**From:** Matthew Siegel <matt@elevatereg.com>  
**Sent:** Monday, November 07, 2016 1:29 PM  
**To:** pzcounter  
**Cc:** birdie9@cox.net; Chun Chin  
**Subject:** Wood River Valley 138KV Transmission Line Questions for 11/10 meeting  
**Attachments:** Questions IPCo 2nd T-Line Public Hearing 11Nov2016.docx

**Idaho Power Transmission Line from North of Hailey to Sun Valley CUP  
Blaine County Planning and Zoning Commission Public Hearing  
Thursday, November 10<sup>th</sup>, 2016**

**Original version shows added distribution lines below transmission lines**

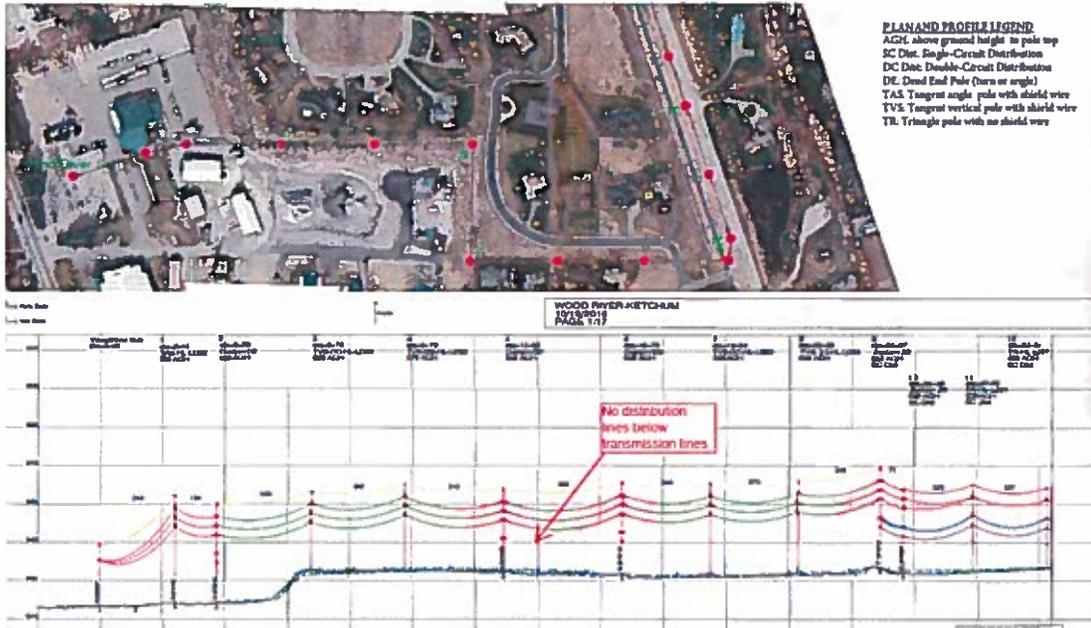
3. Is a new distribution circuit also being added to the second transmission line in the section from Wood River Substation to Buttercup Road? Earlier version of submitted plan and profile drawing showed the distribution lines but it is not shown in the updated version. However, the proposed structure simulation photo still showed the distribution lines. There is a discrepancy. Which is correct?

Structure simulation photo still shows distribution lines

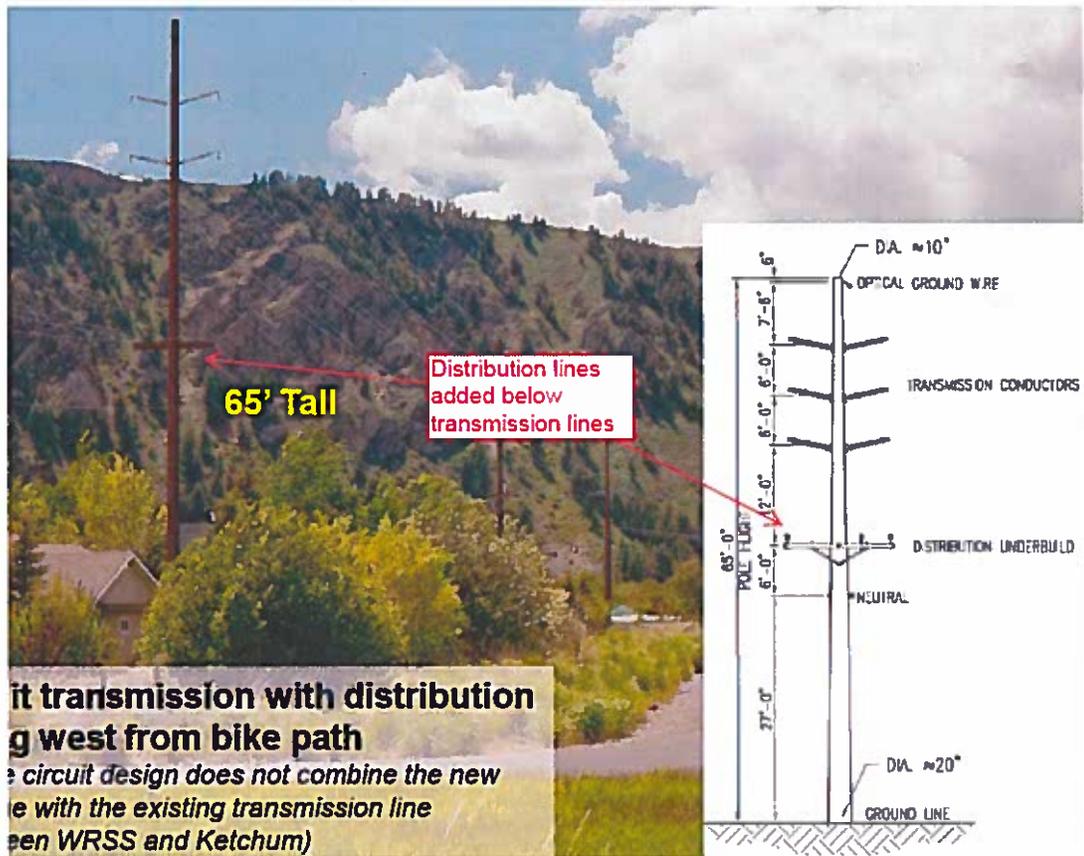
Updated version shows distribution lines taken out.
